Your Ref
WA/59/18/HH
Our Ref
PLAN-023873
Date
16/08/2018

Proposal: Single storey rear & side extensions, new front porch, new door to ground floor east elevation & loft conversion.
Site: 27 Pound Road, Walberton, BN18 0PU.
WA/59/18/HH

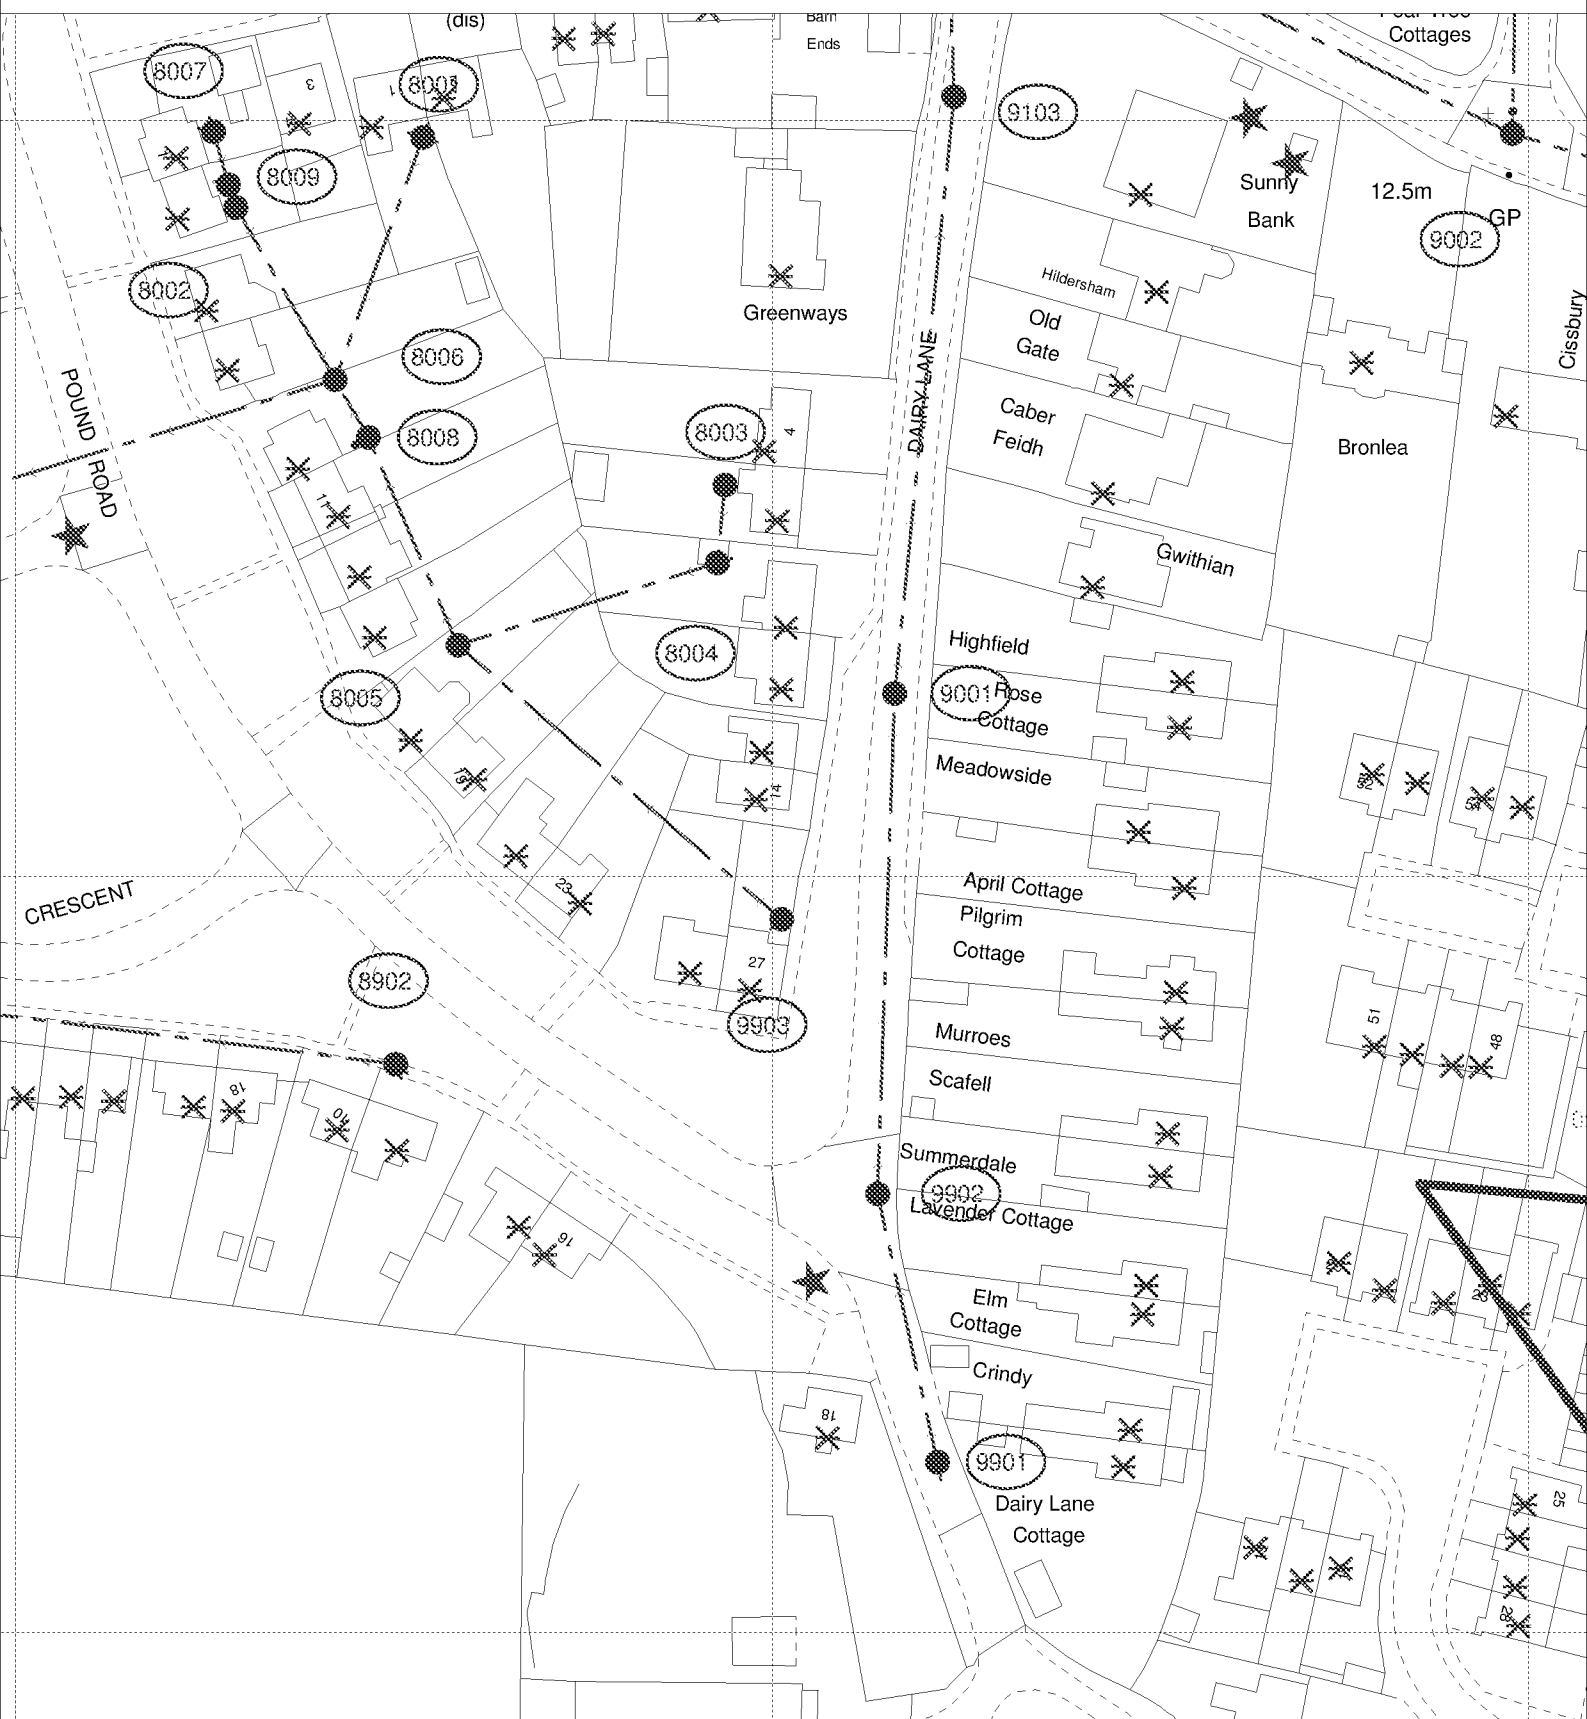
Due to surface water inundation issues in the Lidsey Catchment “The applicant is advised to adopt, where appropriate, the measures in the table “Practical measures to reduce the potential impacts of development”.

Developer should look to protect the public sewerage system from inundation and infiltration, which contribute to flooding in unfavourable conditions.
